Technical Service Bulletin

Mazda North American Operations
Irvine, CA 92618-2922

Subject: KNOCKING / SQUEAKING NOISE FROM FRONT SHOCK ABSORBER, CREAKING NOISE FROM FRONT LOWER ARM BUSHING	Bulletin No.: 02-003/17
	Last Issued: 03/02/2017

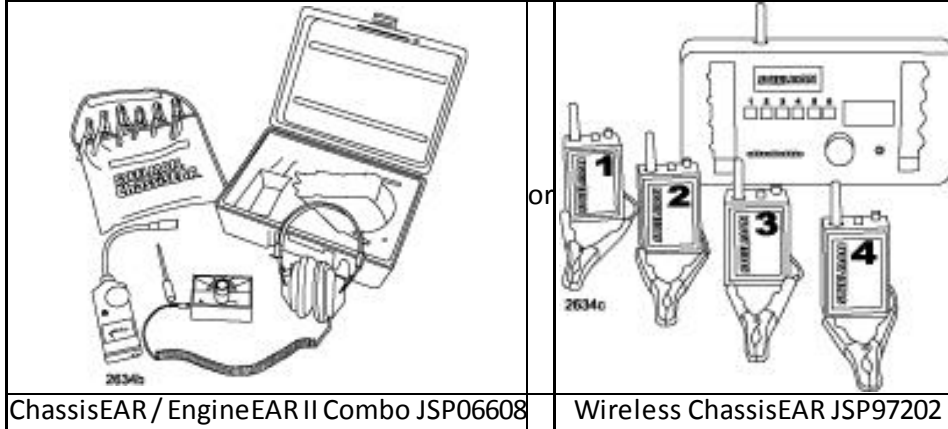
To eliminate the noise, the following mass-production changes have been made:

1. The material and production method of the front strut bearing (A) has been changed. (CX-5 and Mazda6)
2. A protector has been installed onto the coil spring. (CX-5 and Mazda6)
3. The shape of the bump stopper (C) will be modified in the future. (Mazda6 only)
4. The shape of the coil spring has been changed. (CX-3 only)
5. Friction of the lower arm bushing has been reduced by adding a dry coating. (CX-5, Mazda6 and CX-9).

NOTE: The piston rod nut (B) requires replacement.

Install Protector onto Coil Spring (For Vehicle Type A, B and E)

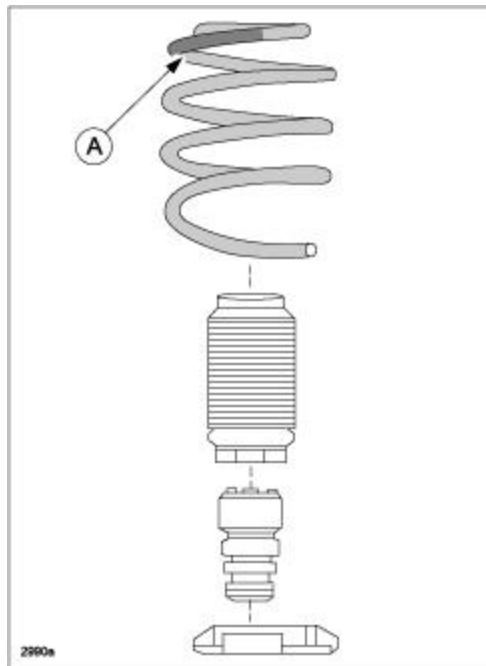
Coil Spring Protector (A) Installation:

1. Starting from the top of the coil spring, degrease the spring 1.5 coils downward.
2. Cut a thin strip of paper to 138 mm in length (or use a cloth type measuring tape).

NOTE: For CX-3, use 130 mm in length.

Replace Bump Stopper (For all Mazda6 vehicles, Type D)

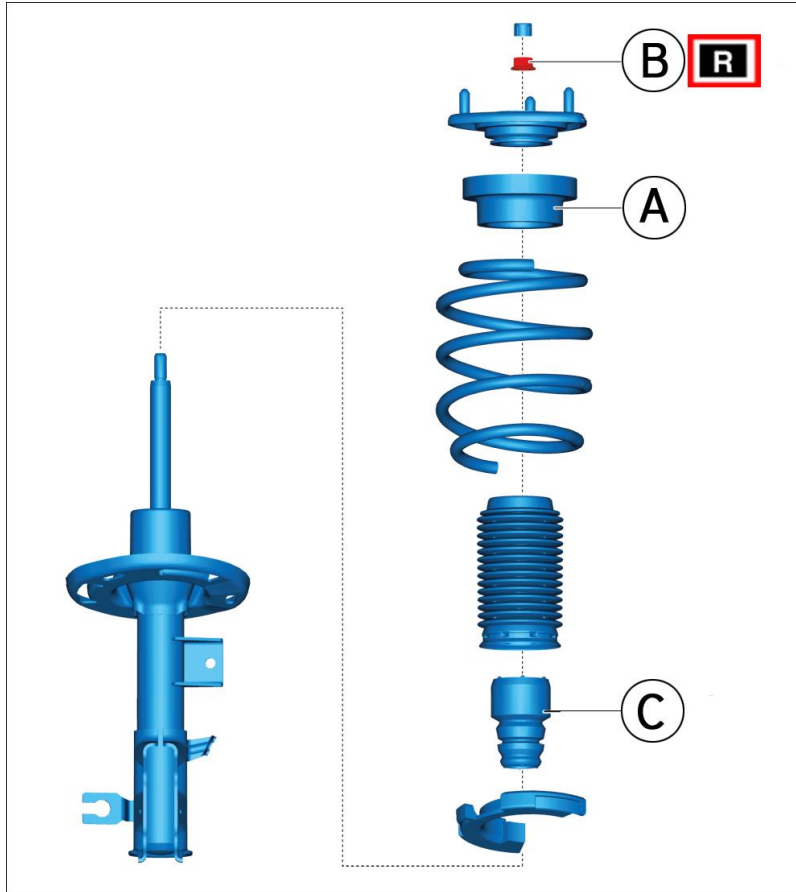
1. Remove the front strut bearing and coil spring according to MS3 online instructions or the Workshop Manual (section 02-13).
2. Replace the bump stopper (C).

3. Reinstall the front strut bearing and coil spring according to MS3 online instructions or the Workshop Manual (section 02-13).
4. Repeat Steps 1 - 3 on the opposite side front suspension.
5. Verify repair.

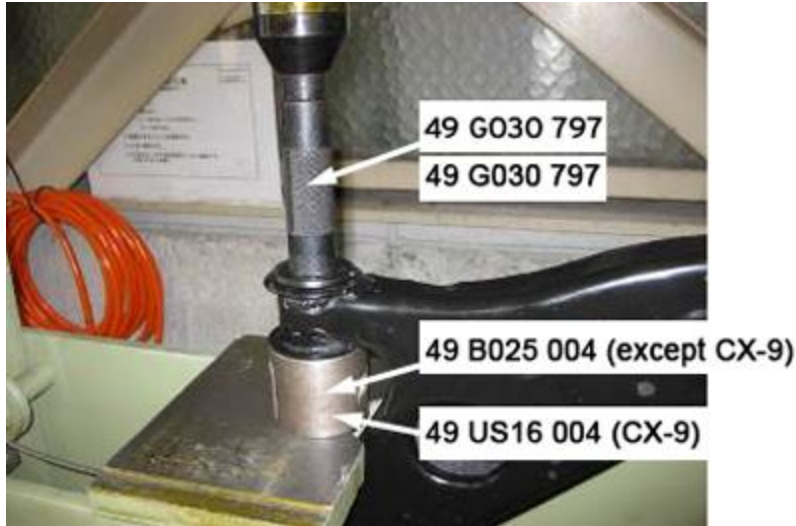
Set SSTs [49 G030 797 and 49 B025 004 (except CX-9) / 49 US16 004 (CX-9)]and the front lower arm on a shop press as shown in the figure and remove the front lower arm bushing.

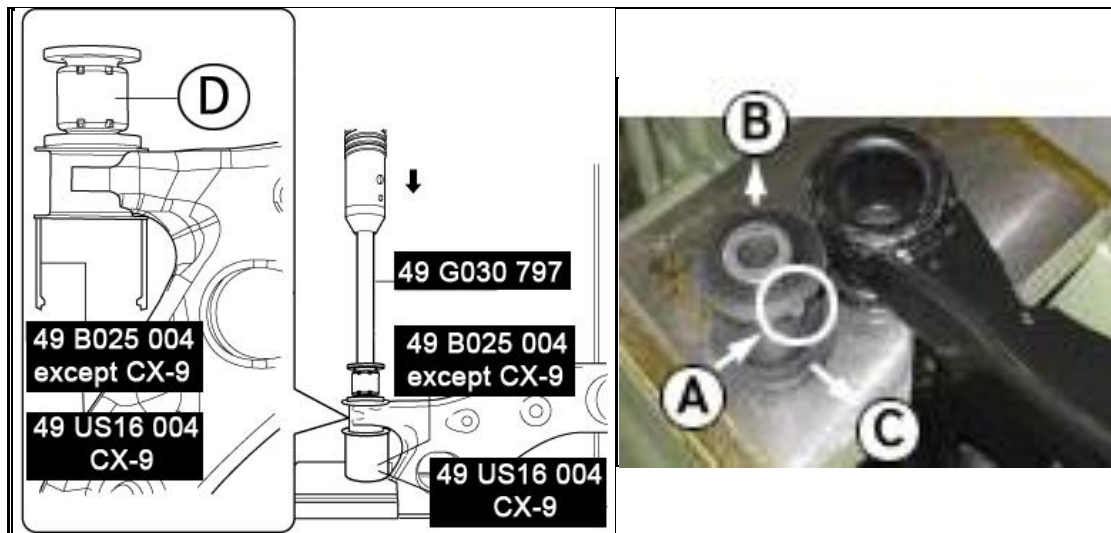
3. Install the front lower arm bushing (D) using SSTs.

Install the front lower arm bushing so that the projection (A) shown in the figure is pointing toward the front (B) and out of the vehicle (C).

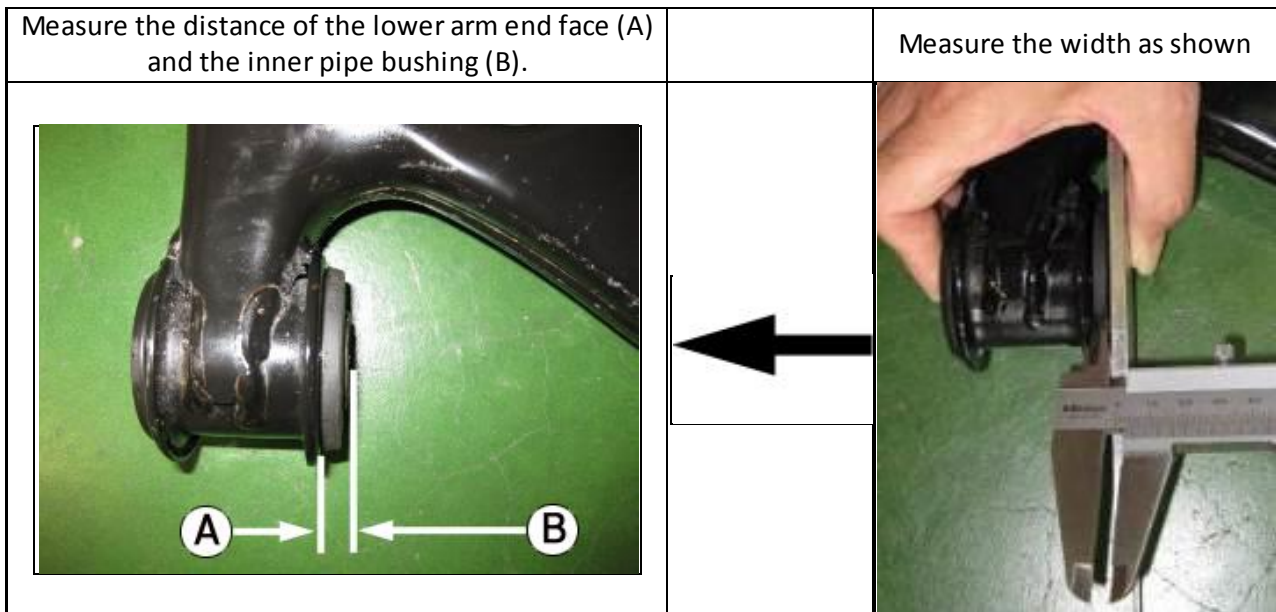
4. After the installation, verify that the front lower arm bushing has been installed to the correct position by the procedure shown in the figure.

Specification: Width: 5.6 +/- 0.8mm (0.22 +/- 0.03 in)
